Diana Memorial Garden

THE PLAYGROUND DEDICATED TO THE MEMORY OF DIANA, PRINCESS OF WALES, KENSINGTON GARDENS, LONDON

Kensington Gardens Royal Park - Playground Development

May I comment on this planning application (PP/99/02384). First, I refer you to my letter of 18 October to Mr. McErlean of the Royal Parks (of which you were sent a copy) which gives some views on the playground plans.

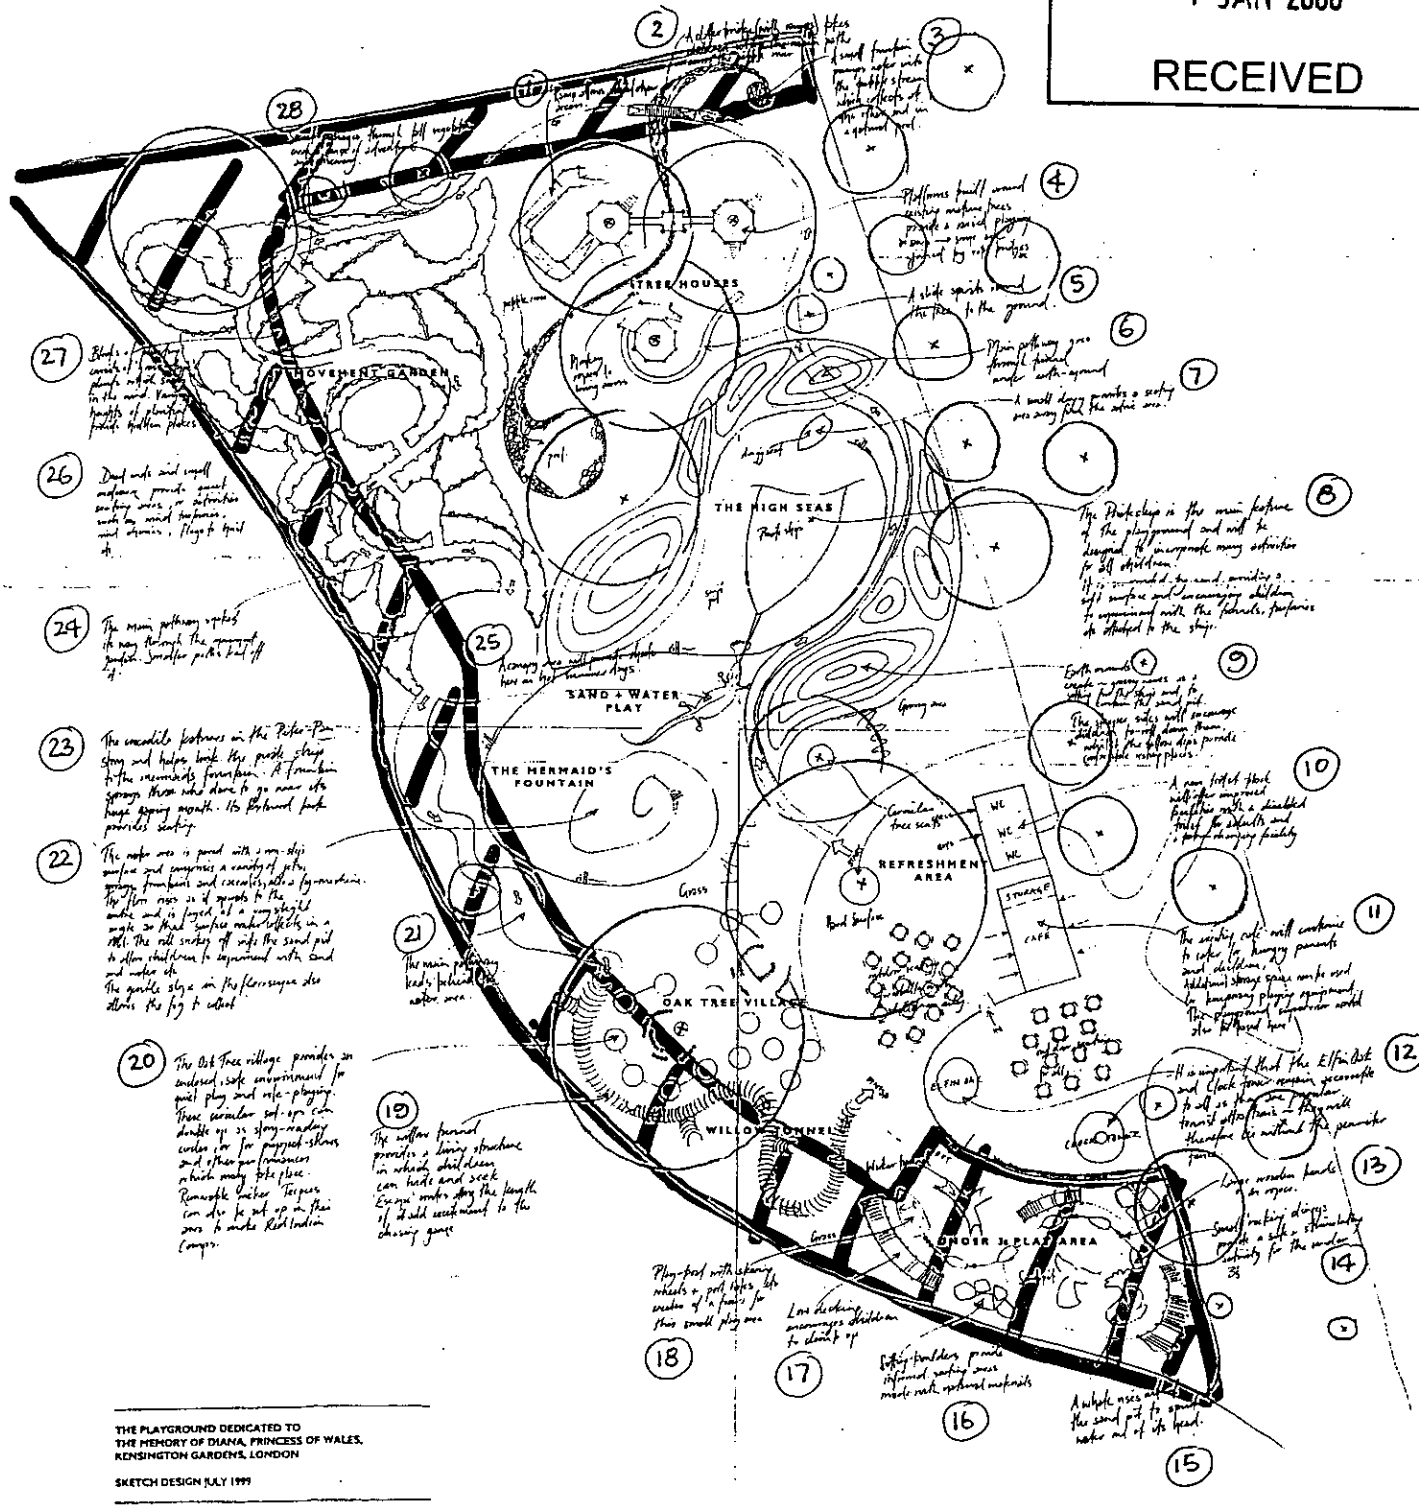
HATCHED AREA DENOTES AREA OMITTED FROM PROJECT ON 28 OCTOBER 1999
